**COMMONWEALTH OF VIRGINIA  
STATE CORPORATION COMMISSION**

CASE NO. PUE-2009-00043

For certificates of public convenience  
and necessity to construct facilities:  
765 kV Transmission Line through  
Loudoun, Frederick, and Clarke Counties

DIRECT TESTIMONY

Figure 1  
Highlighted lines indicate the areas of alleged 500-kV overloads relevant to PATH.

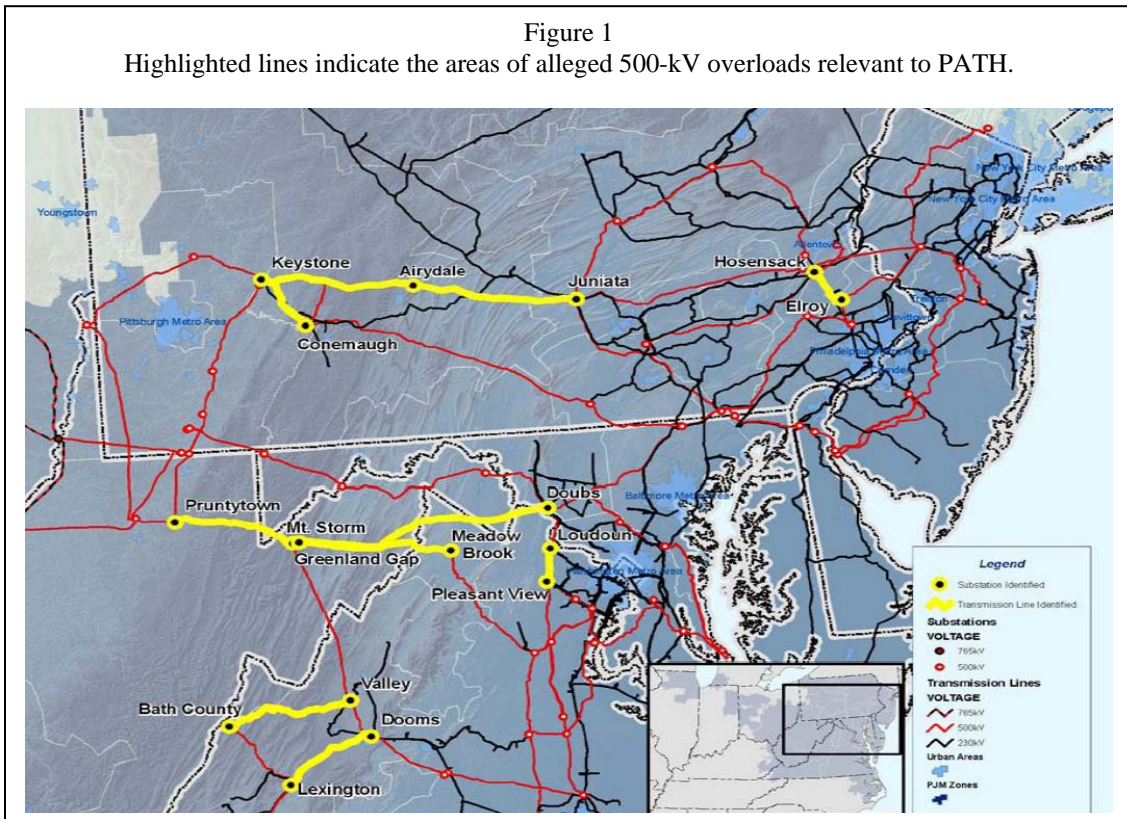
4 A: Figure 1 and Table 3.4, both from the 2007 RTEP, will be helpful in following the  
5 discussion below.
